> **Re:** **EB-2022-0044 – Kingston Hydro Corporation**
> **Application for 2023 Electricity Distribution Rates**
> **Interrogatories of the Vulnerable Energy Consumers Coalition (VECC)**

Figure 5.2-18 – 2015 to 2021 System Reliability Indices 2 **Excluding Loss of Supply and Major Event Days**

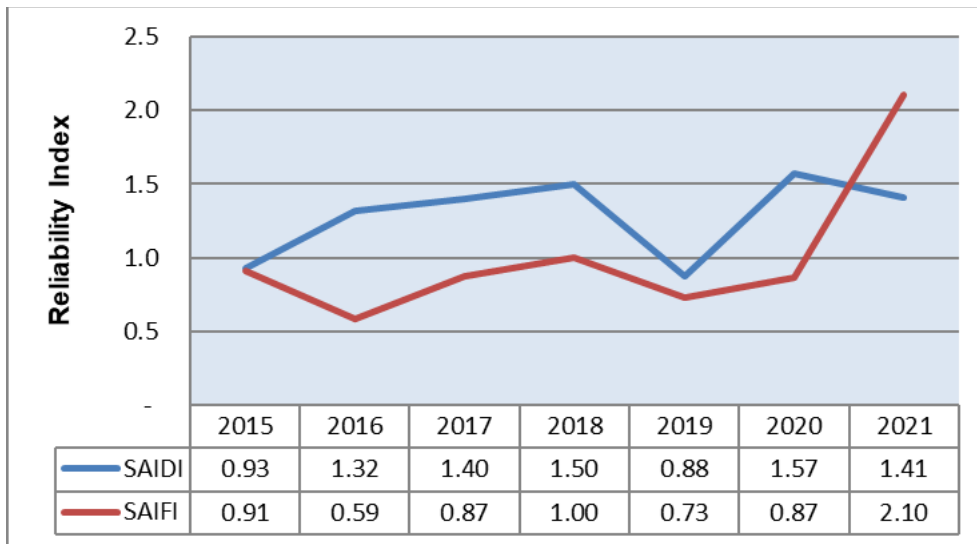
a) The above chart shows a major degradation in reliability in 2021. Is the explanation provided at page 70 of 505 of the DSP the reason for this major shift?
b) What changes were made subsequent to this failure to reduce the risk of customer owned equipment causing outages to other customers?
